**PROPOSED ESKOM NUCLEAR POWER STATION
AND ASSOCIATED INFRASTRUCTURE**

ENVIRONMENTAL IMPACT ASSESSMENT (EIA: 12/12/20/944)

**COMMENTS ON
DRAFT ENVIRONMENTAL IMPACT ASSESSMENT REPORT**

(Volume 51 RDEIR IRR 04 August 2011)

Number of Accidents with at least 5 Deaths in Full Energy Chain 1969 to 2000

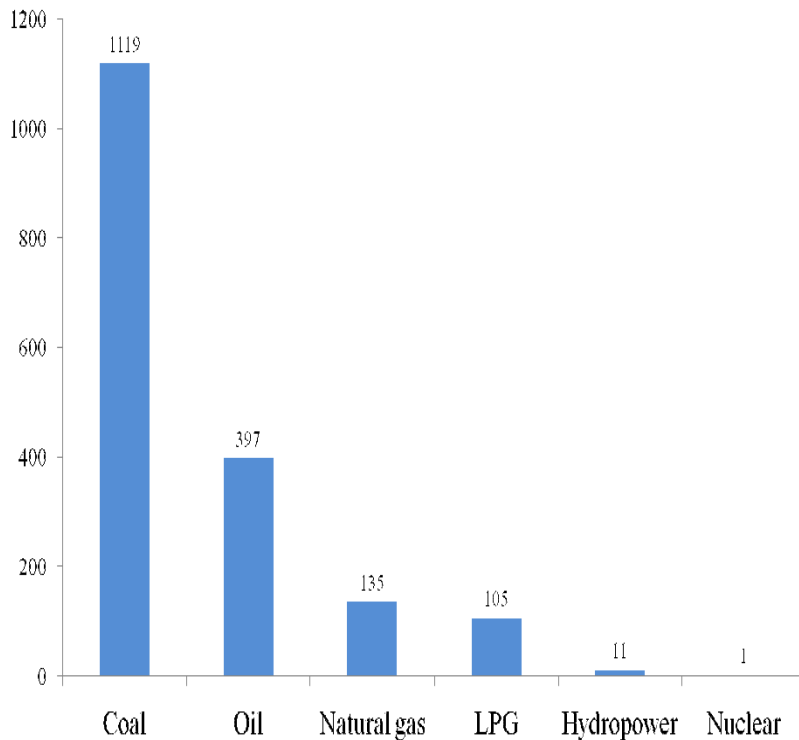
However, can one use the graph below to counter argue the statement? Or will this become a ping pong game where various research materials are countered against each other?

Figure 1: The Historic Crossover – Solar photovoltaic costs are falling as new nuclear costs are rising.¹

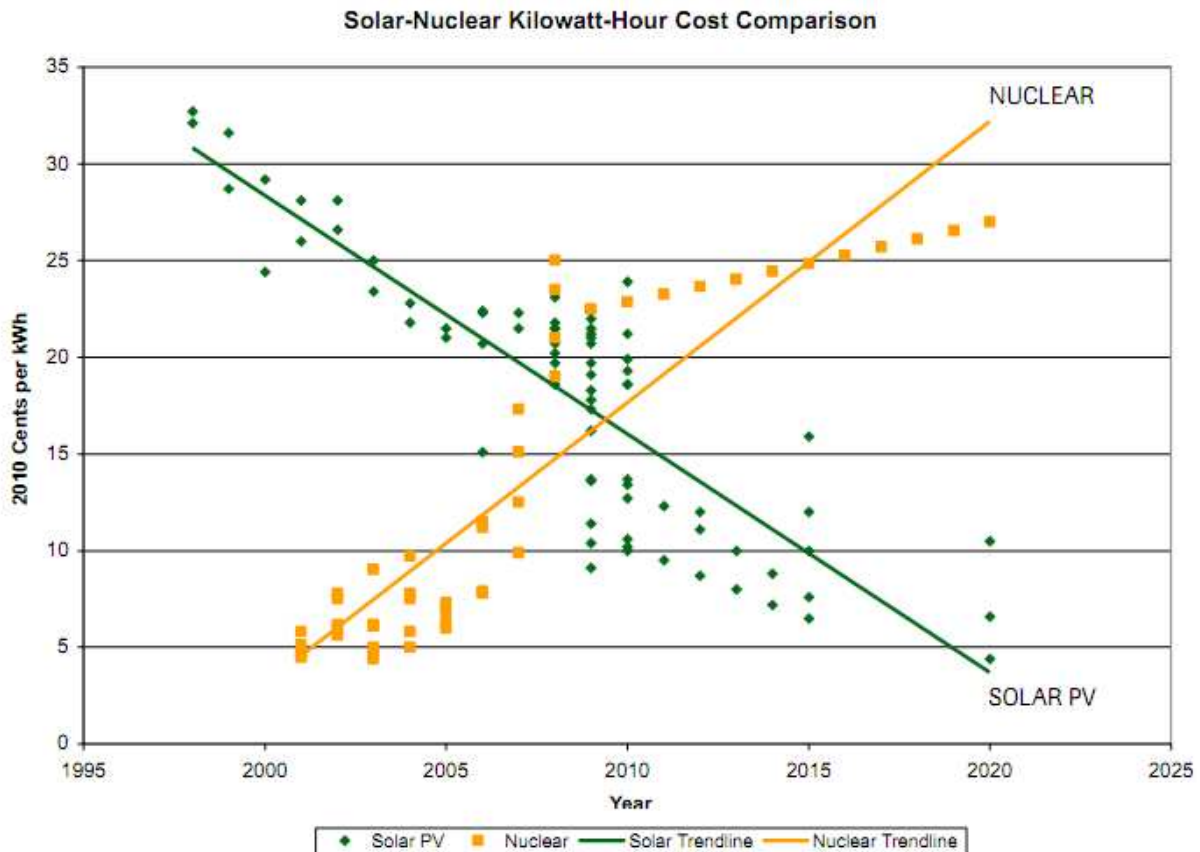
The cost estimates of photovoltaic systems used in the EIR is out by orders of magnitude. The given price per watt for a 125 MW solar farm is 5 to 10 times the hardware store retail prices of domestic portable 100 watt panels. See www.solarbuzz.com for photovoltaic costs. They provide a consulting service and they should be able to provide pricing data for large systems based on real world experience and independent analysis of price trends.

In a "historic crossover," the costs of solar photovoltaic systems cheaper a cheaper option than Nuclear power in 2010.
